**Case #BZA25-000017**  
**Kiawah Island BZA Meeting of December 15, 2025**

**Request:** Variance request for the reduction of the required 10' side setback for approximately 22 square feet for a proposed generator stand

**Case # BZA25-000017**  
**BZA Meeting of December 15, 2025**  
**Subject Property: 44B Eugenia Ave– Kiawah Island**

THE RICHARDSON RESIDENCE  
**44-B EUGENIA AVE.**  
NEW GENERATOR & PLATFORM

**PROPOSED SITE PLAN**  
SCALE: 1" = 10'-0"

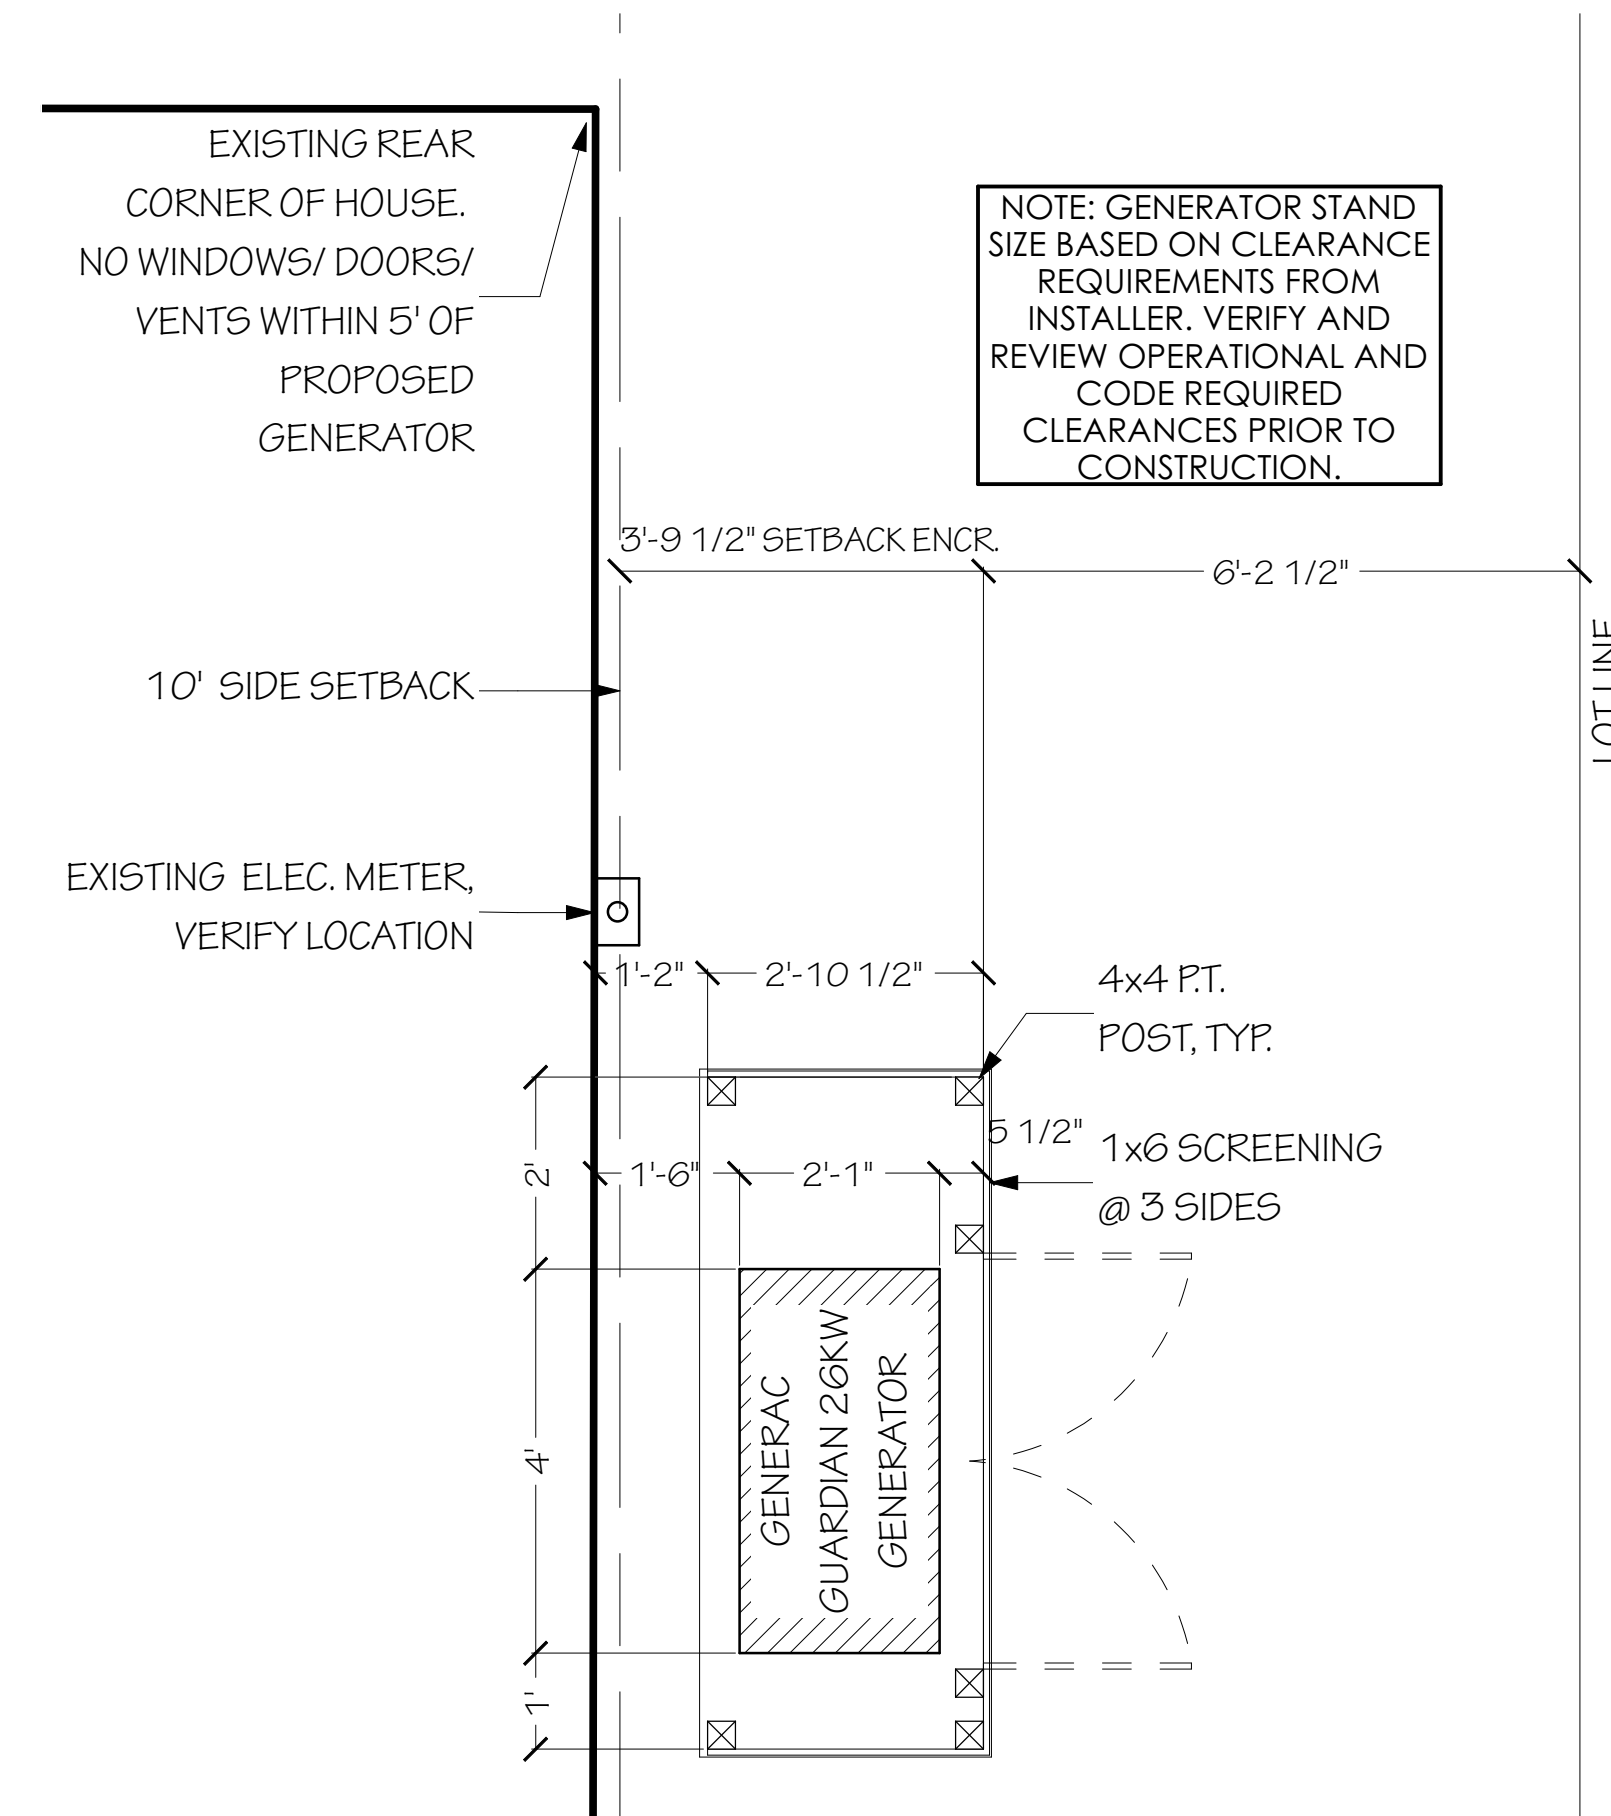
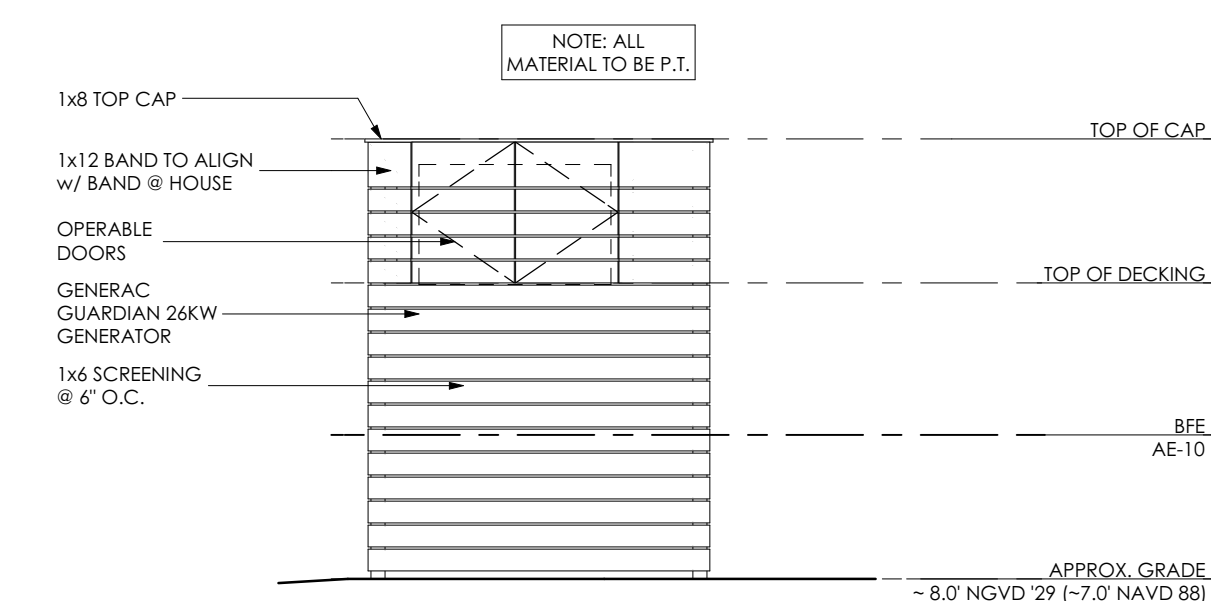
The applicant's proposed plans include a generator stand on the right side of the home inside the right-side setback. The proposed generator stand extends approximately 3 ft. 9 ½ inches into the required 10-foot right side setback. The distance from the generator stand and the property line is approximately 6 ft. 2 ½ inches. The dimensions of the proposed generator stand are approximately 7 ft. by 2 ft. 10 & ½ inches. The total encroachment into the required right-side setback is approximately 22 square feet. There are no proposed changes to the building footprint. The proposed lot coverage is 24.4%.

Pursuant to the conditions of Sec. 12-64. Setbacks. the proposed generator is less than ten feet from the adjacent side property line, and therefore does not qualify for the administrative relief.

A NEW WHOLE HOME GENERATOR & EQUIPMENT PLATFORM  
NOTE: 22 SF OF ENCROACHMENT INTO SIDE SETBACK. ZONING VARIANCE REQUIRED

**1. The applicant shall submit a landscape plan to be approved by the Planning Director providing appropriate screening for the proposed encroachment.**
